# UNITED STATES PATENT AND TRADEMARK OFFICE

APPLICATION NO.	FILING DATE	FIRST NAMED INVENTOR	ATTORNEY DOCKET NO.	CONFIRMATION NO.
10/075,371	02/15/2002	Kalyan Handique	10255-029-999	9738
26171	7590	09/13/2006		
FISH & RICHARDSON P.C. P.O. BOX 1022 MINNEAPOLIS, MN 55440-1022			EXAMINER SINES, BRIAN J	
			ART UNIT	PAPER NUMBER

**Office Action Summary**

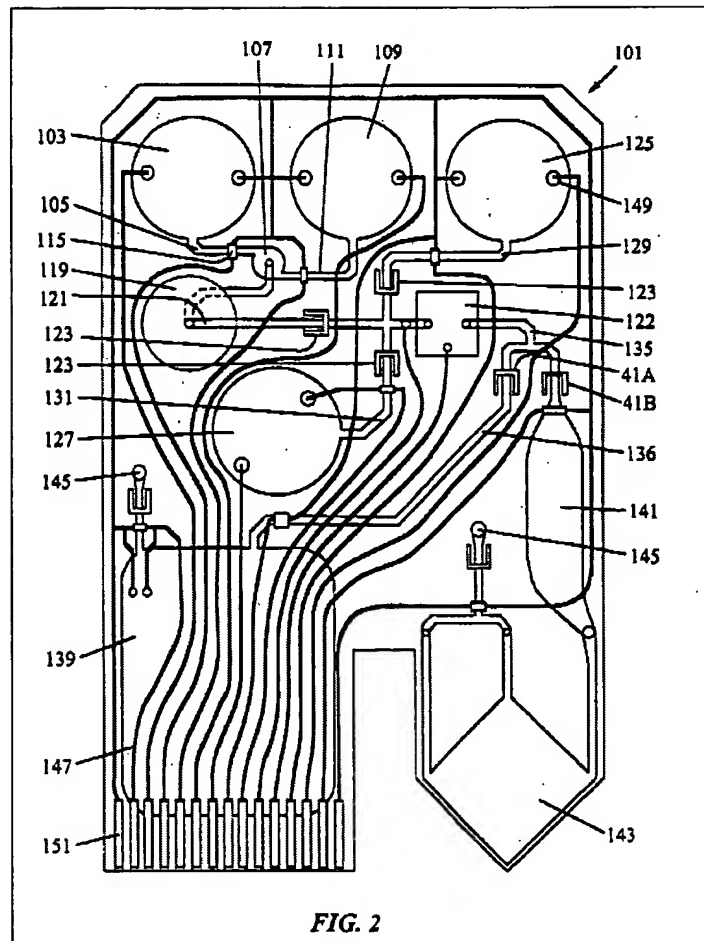
Regarding claims 32, 49, 50, 53, 57 – 61, 63, 64, 66, 68, 69, 70, 72 – 74 and 76, Pourahmadi teaches a microfluidic device 101 comprising: an enrichment module or zone (flow-through component 122); a cell lysing module 119; a mixing module 107; and a DNA manipulation module 143 for performing PCR amplification (see col. 4, line 65 – col. 6, line 47; figure 2). Pourahmadi teaches the incorporation of valves for facilitating fluid flow control within the disclosed device (see, e.g., col. 14, lines 39 – 51).

Regarding claims 51 and 52, Pourahmadi teaches that the flow-through component 122 can comprise a chamber comprising an absorbent material, such as filters, beads, fibers, membranes, polymers and gels (see, e.g., col. 6, lines 1 – 7; figure 2).

Regarding claim 65, as shown in figure 2, Pourahmadi teaches that mixing module 107 comprises various connecting channels (e.g., channels 111, 105, etc.).

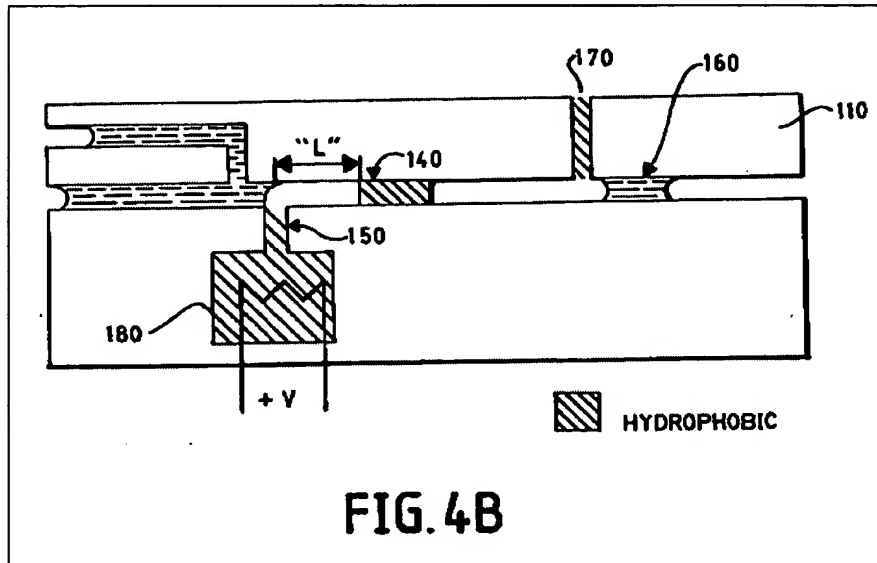
Handique teaches a system and methods for microdroplet preparation with microfluidic devices. Handique further teaches a thermopneumatic apparatus for facilitating fluid transport in microfluidic devices (see col. 13, line 60 – col. 15, line 40; figures 3A, 3B, 4A & 4B). As shown in figure 4B, the system taught by Handique comprises a thermopneumatic gas actuating system

denoted by 180, a hydrophobic gas vent 170, and an outlet, which is located to the right of the sample 160 and at the end of the channel containing the sample. Therefore, it would have been obvious to a person of ordinary skill in the art to incorporate a microdroplet preparation module with an associated actuator as claimed to facilitate sample fluid transport. Handique further teaches that the disclosed microdroplet preparation module comprising a non-wetting positioning element (e.g., a hydrophobic patterned surface) can be configured to split microdroplet samples (see, e.g., col. 30, lines 44 – 57).

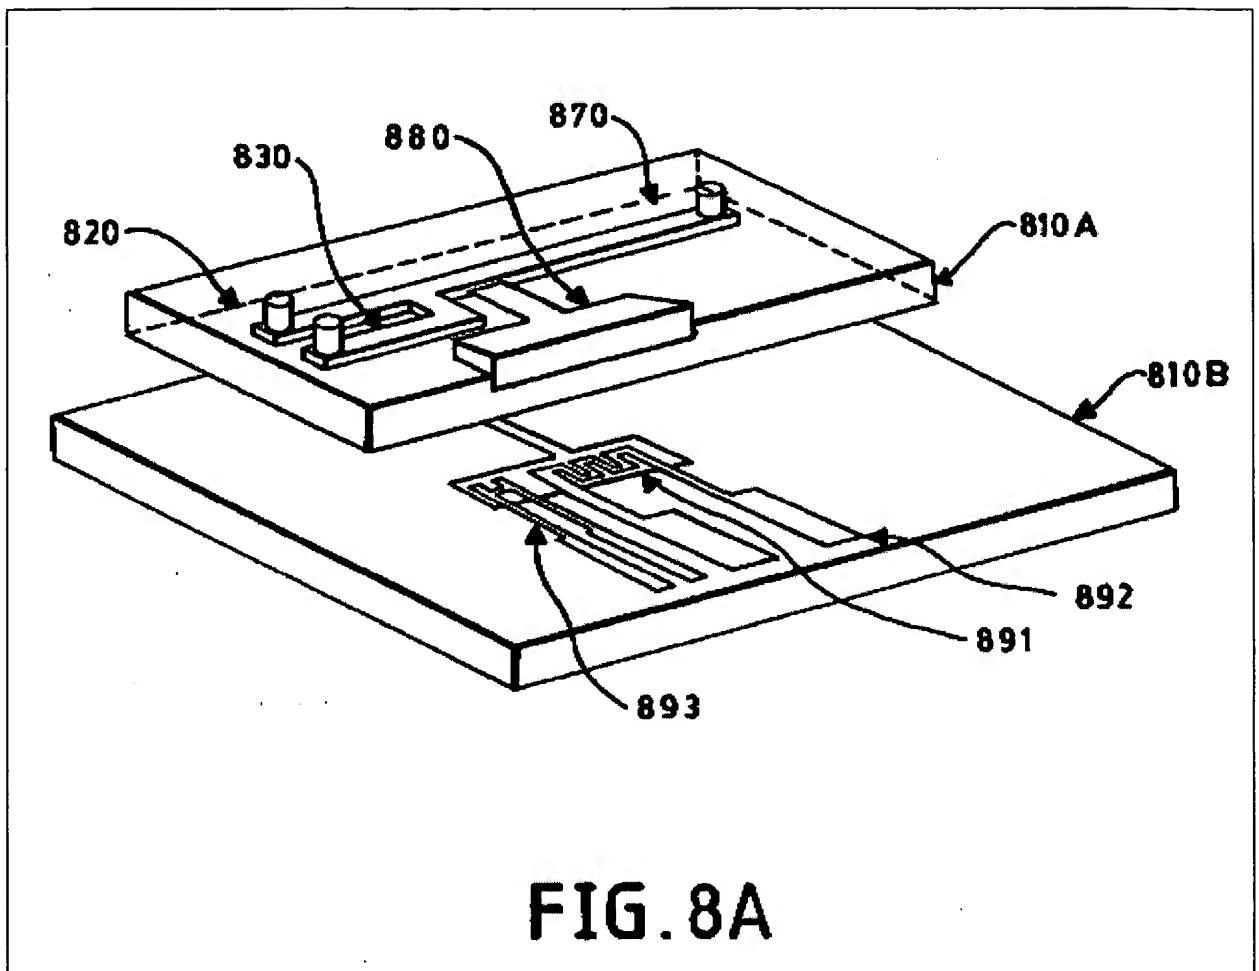
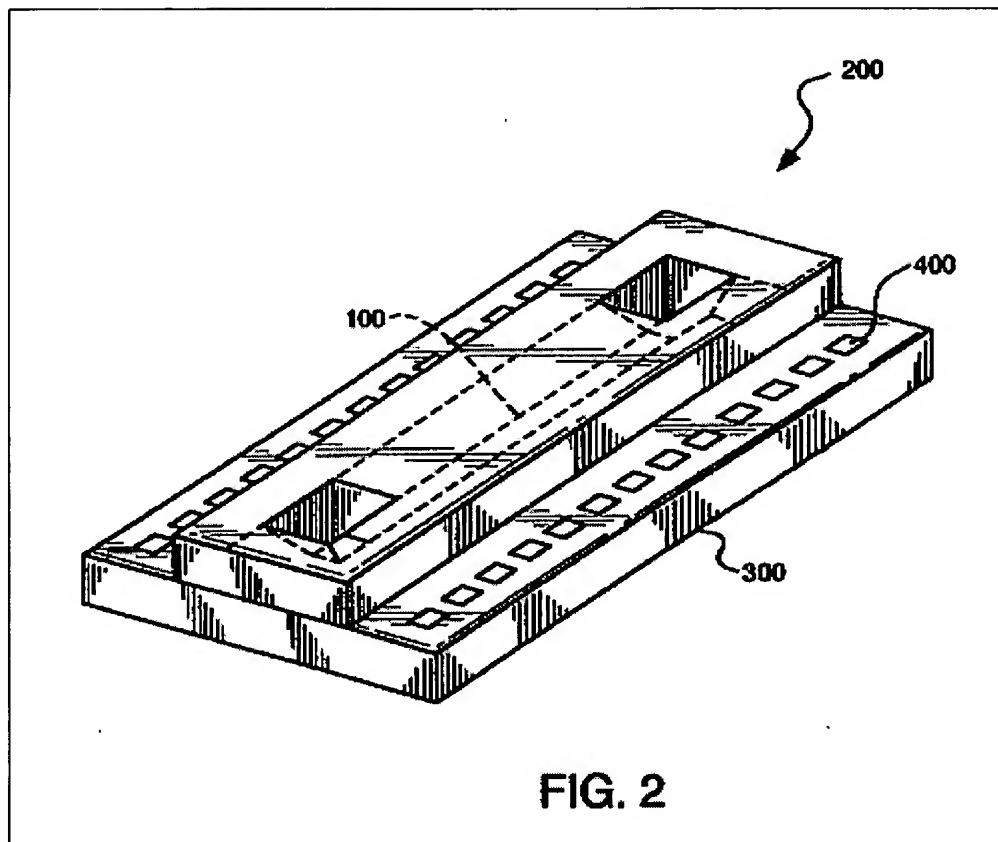
Handique teaches a microfluidic device configuration comprising a lower silicon dioxide substrate 810B and an upper glass substrate 810A. The bottom surface of the upper glass substrate 810A has channels and chambers etch into it. The lower silicon substrate comprises a heating element 891 (see col. 20, lines 5 – 13; col. 26, lines 1 – 29; figure 8A). The resistive heating elements comprise a metallic aluminum film (see col. 20, lines 13 – 22). The substrate layers are bonded together (see, e.g., col. 21, lines 29 – 33).

Handique further teaches a device configuration comprising a lower substrate 300 having a base comprising glass and an upper substrate 200 comprising silicon. The top substrate 200 has microchannels 100 (see col. 13, lines 48 – 59).

Regarding claim 40, Handique teaches the incorporation of contact pads, electric leads or terminals 892 associated with heater 891 and which is exposed at the edge of the lower substrate 810B (see col. 20, lines 5 – 12; figure 8A). In addition, Handique teaches the incorporation of electrical pads or terminals 400 on the edge of lower substrate 300 in the device shown in figure

Regarding claim 56, as indicated in figure 8A, Handique teaches that when the device is fully assembled, the heater 891 in the lower substrate 810B is joined with the chamber 880 in the top substrate 810A, thereby forming the thermopneumatic gas actuator located within and spanning both of the substrates. The incorporation and use of a one-piece, integrated construction instead of the structure disclosed or taught in the prior art would have been within the ambit of a person of ordinary skill in the art (see MPEP § 2144.04). Therefore, it would have been obvious to a person of ordinary skill in the art to integrate a gas actuator with the upper substrate of the disclosed device as claimed.

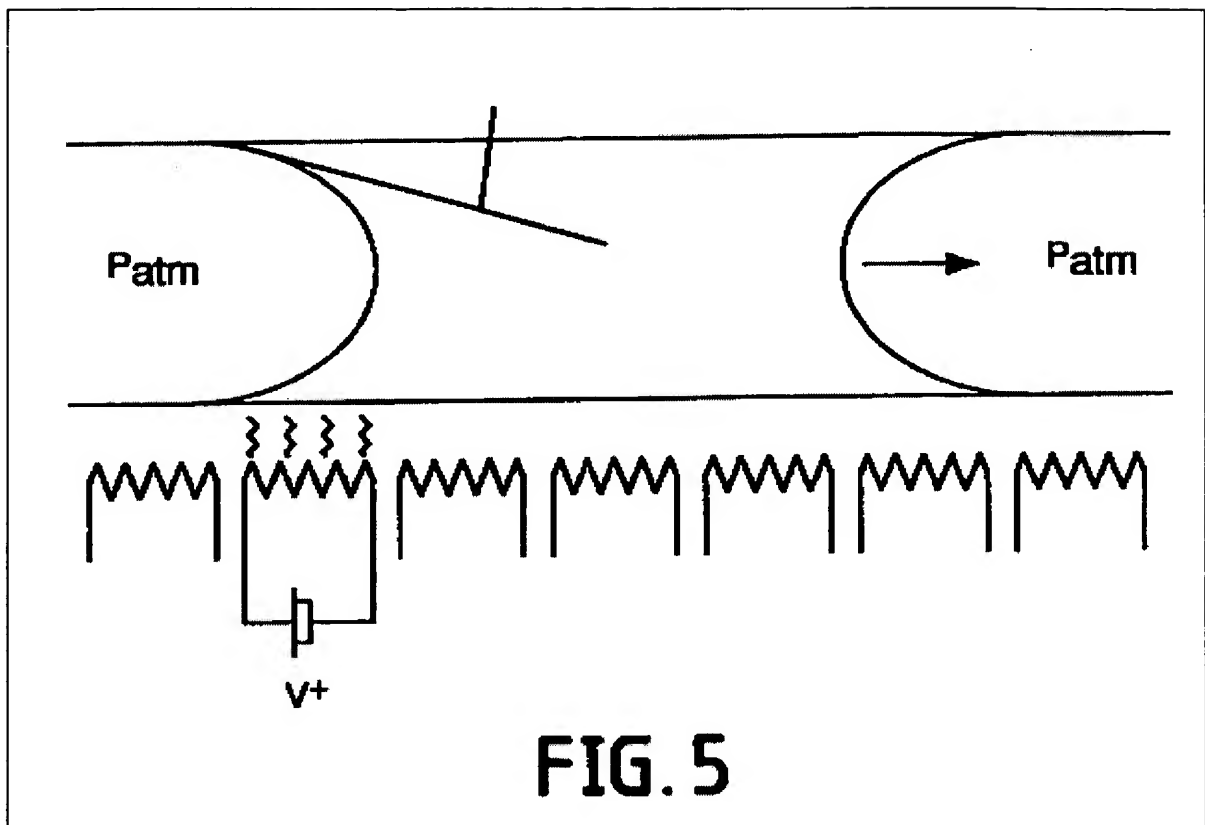
As indicated in figure 5, a plurality of successive heaters can be arranged in a substrate and along the length of a channel for facilitating fluid transport through the channel (see col. 15, line 41 – col. 16, line 23).

Regarding claims 54 and 55, Handique teaches the incorporation of a single thermopneumatic gas actuator (e.g., chamber 180 including the resistive heater) located beneath a channel within device 110 (see, e.g., figure 4A; col. 14, line 58 – col. 15, line 21). As shown in figure 5 above, Handique teaches the incorporation of a plurality of successive heating elements located underneath a single channel or chamber within the disclosed device for moving fluid through the device. The mere duplication of parts, without any new or unexpected results, is within the ambit of one of ordinary skill in the art (see MPEP § 2144.04). Therefore, it would have been obvious to a person of ordinary skill in the art to incorporate a plurality of resistive heating elements within the disclosed device as claimed in order to facilitate effective fluid transport.
